# Gloucester Coal Seam Gas Project

PEER REVIEW OF GROUNDWATER STUDIES –  
REPORT TO GLOUCESTER COMMUNITY  
CONSULTATIVE COMMITTEE

- FINAL
- 3 May 2012

■ **Figure 1 Groundwater levels and rainfall at S5MB nested site**

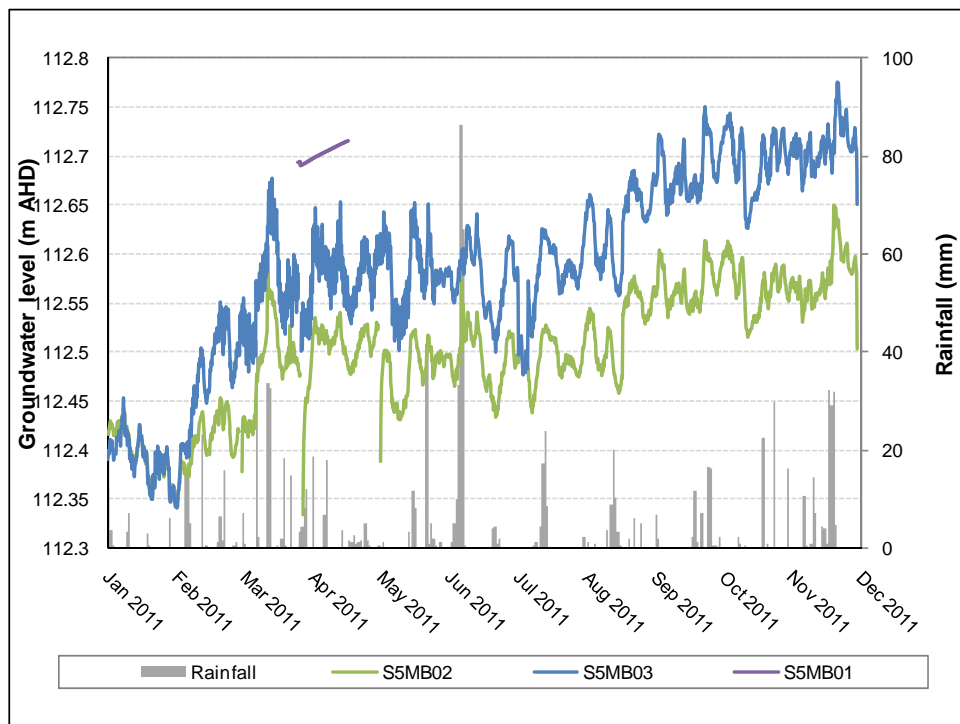
**S5MB02** (Sc. : 89 – 95m, Sandstone/siltstone) and **S5MB03** (Sc: 158-164m, Coal/shale) – The effect of the high rainfall in mid-June 2011 (195 mm between 13th and 16th June 2011, as measured at the Gloucester, Hiawatha, rainfall gauge) is apparent in these two bores. The rise in the hydrograph after the intense period of rainfall may not be coincidental. There is a delay of approximately one to two months before the hydrographs begin to rise, which may be the time for the pressure transmission of the recharge event to impact the point in the aquifer where the bores are screened. This suggests there is hydraulic continuity laterally within the units (and also possibly vertically), and that the hydraulic conductivity is not negligible. (The one to two month delay suggests this water level rise is not caused by a hydraulic loading effect).

Further, regardless of the link between the June 2011 rainfall and hydrograph response, there is a total rise in groundwater elevation of around 0.3m and 0.4m within the 12 month monitoring period (for S5MB02 and S5MB03 respectively), indicating recharge is occurring. There is also a very strong correlation in the micro-fluctuations between S5MB02 and S5MB03. This may be explained solely by barometric response, however an analysis of water levels with barometric effect removed is recommended to confirm that this is the case.

■ **Figure 2 Groundwater levels and rainfall at S4MB nested site**

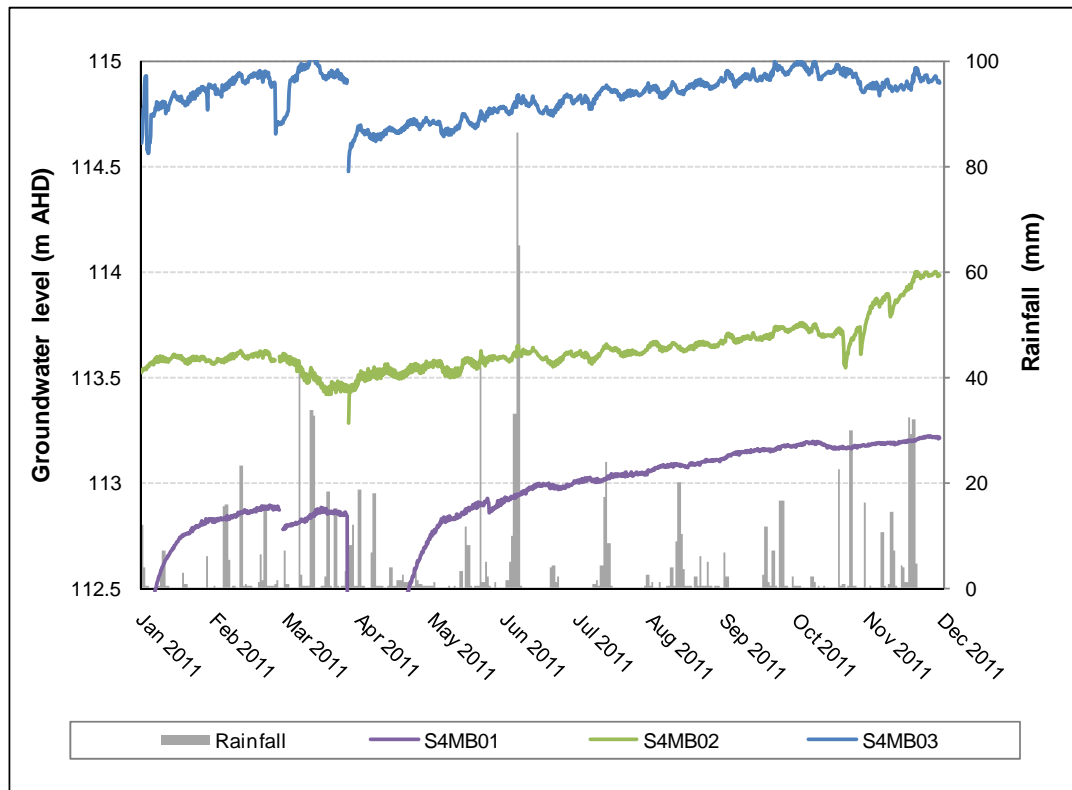
**S4MB01** (Sc. : 58 – 64m, Sandstone) – This bore does not show a clear response to the high rainfall in mid-June 2011 (e.g. as observed at the S5MB nested site), but (excluding the first month of data which may have been influenced by sampling/testing), does show an increase in water level of 0.5m over 2011.

**S4MB02** (Sc. : 89 – 95m, Sandstone/siltstone) – This bore shows a similar overall trend to S4MB01 (above) with an increase in water level of 0.5m over 2011. For this bore and S4MB01, the yearly increase in water level is the same as the deeper bore screened in the coal at this nested site (S4MB03, Sc: 162-168m) which is also 0.5m. Fluctuations at a small scale (e.g. weekly) do not always correspond across these three bores, but the annual increase in water level is similar. In contrast to the above statement (p80 in the PB report) this suggests that these units are responding to the effect of rainfall recharge, or else possibly recovery from flow testing in 2010. Either way, the results do not support a conceptual model of hydraulic isolation of interburden layers.

■ **Figure 3 Groundwater levels and rainfall at TCMB02**

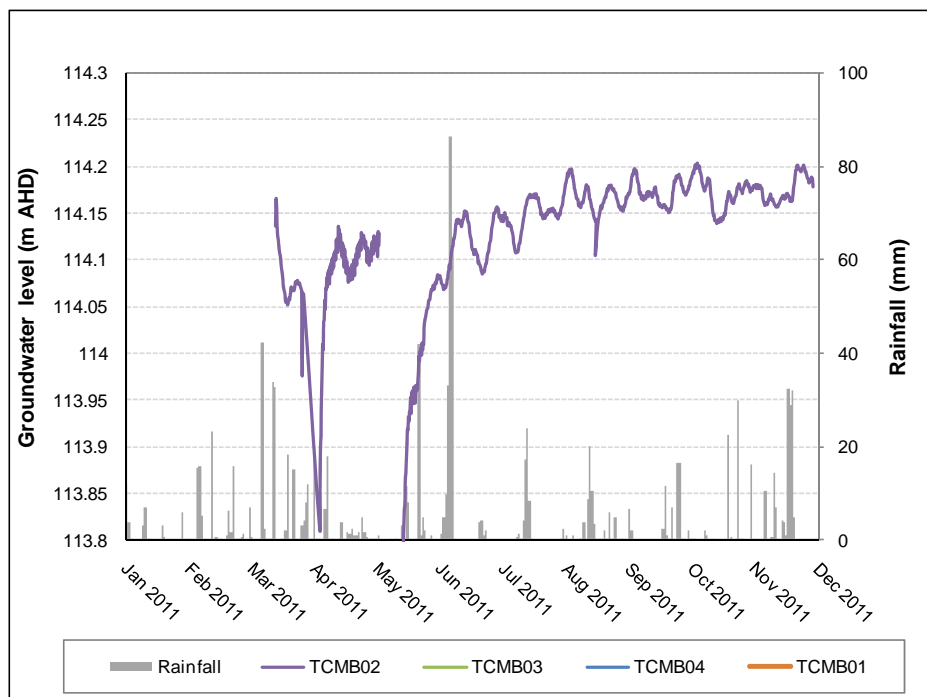
**TCMB02** (Sc.: 175 – 181m, Sandstone) – This bore exhibits a rise in water levels of around 0.15m within the monitoring period (ignoring the impact of the hydraulic testing and sampling on the bore), as shown in Figure 3.

■ **Figure 4 Groundwater levels and rainfall at TCMB03 and TCMB04**

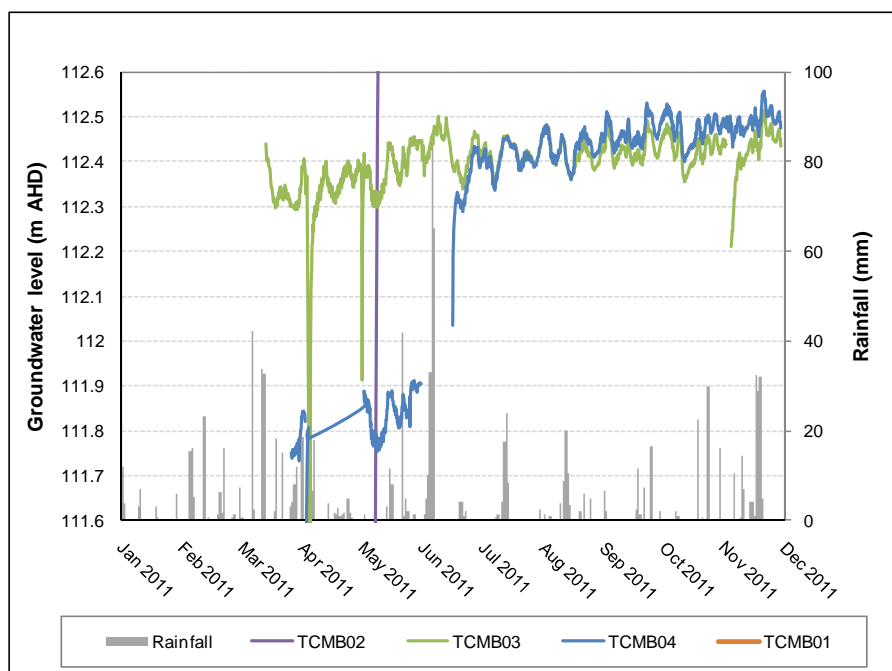
**TCMB03** – (Sc.: 260 – 266m, Coal and Sandstone) – The PB report states that this bore shows “negligible seasonal variation and no response to rainfall recharge” (PB, 2012: 80). Figure 4 shows that there has been a water level rise of around 0.2m within the monitoring period. This suggests the bore is responding to recharge.

**TCMB04** – (Sc.: 327 – 333m, Coal and Sandstone) – The PB report states that this bore shows “negligible seasonal variation and no response to rainfall recharge” (PB, 2012: 80). Figure 4 shows that there has been a water level rise of around 0.75m within the monitoring period. However, correspondence from AGL post the draft IPR indicates that the early data in this bore is not representative due to the bore being ‘shut in’ to monitor gas build up. The bore was vented in June 2011, which has resulted in the step change apparent in the hydrograph at this time. Examining only the data after June 2011, there has been a water level rise of around 0.45m in this bore. If the steep rise in the data in late June is assumed to be part of the bore re-equilibrating

after the venting (and also assumed invalid), then there is a water level rise of around 20cm post-June 2011 in the bore. Regardless which interpretation is correct, it is apparent the bore is responding to recharge. This response is particularly significant given that this is the deepest of the monitoring bores, and screened in one of the target coal seams.

- **Figure 5 Hydraulic conductivity results for shallow rock and interburden from PB (2012) field program**

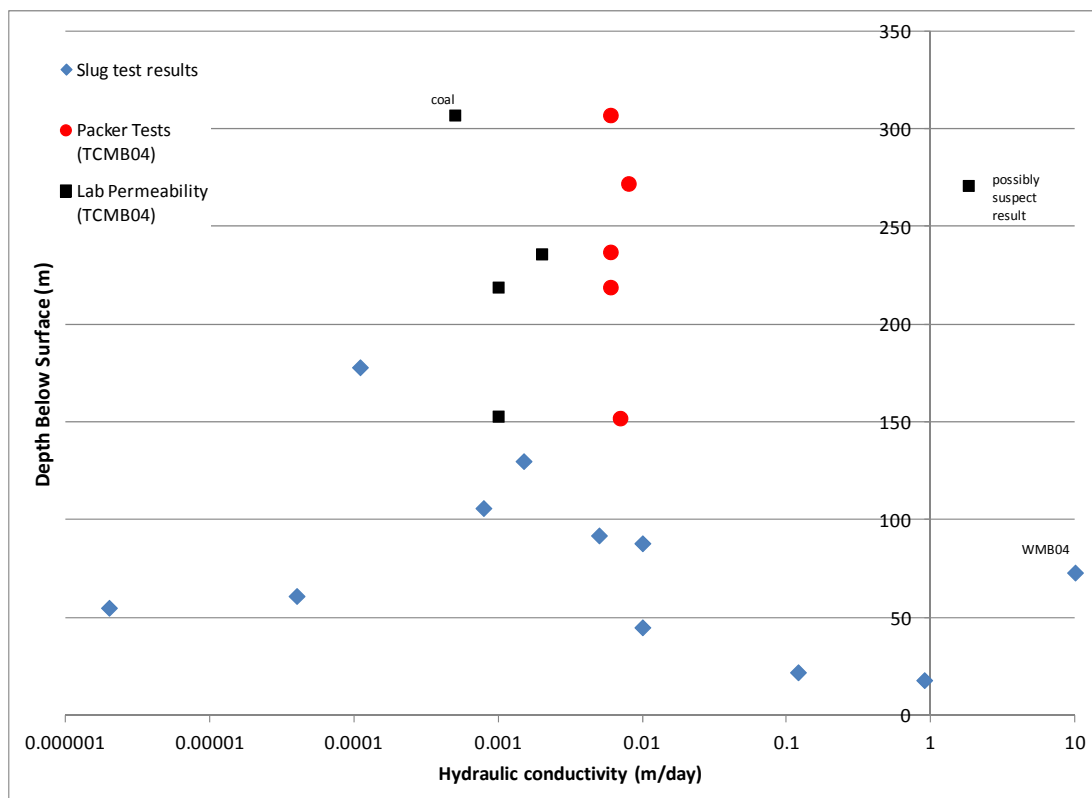
At the nested site where the three slug tests were undertaken (TCB02, 03 and 04), the alternate method (packer tests and core permeability in the laboratory) at the same depth returned a significantly higher hydraulic conductivity, ranging between 30 to 900 times higher. (A comparison with the exact depth was not possible, but was interpolated between the lab and packer tests). If the packer tests and laboratory tests are more accurate, does this mean the remainder of the bores which have only been slug tested (19 tests) are an underestimate of actual hydraulic conductivity?

The literature generally indicates that laboratory permeability tests tend to underestimate actual regional hydraulic conductivity (e.g. Hart, 2006) compared to insitu tests because they do not measure secondary permeability (i.e. fracture flows). If this is the case at this site, this compounds the issue described above as the lab tests indicate higher permeabilities than the packer tests.

A further observation from Figure 5 is that the packer and laboratory tests do not indicate a trend of decreasing hydraulic conductivity with depth. Again, some explanation of why this may be the case is required, as the current conceptual model appears to be based on the slug test results but ignores the packer and laboratory tests.

- iii. consideration of reasons for the absence of a trend in hydraulic conductivity and depth for the packer and lab test data.
  - iv. representative values for the four hydrostratigraphic units should be proposed (recognising that this may change during model calibration). Upper and lower bounds that will be permitted within the model should also be described.
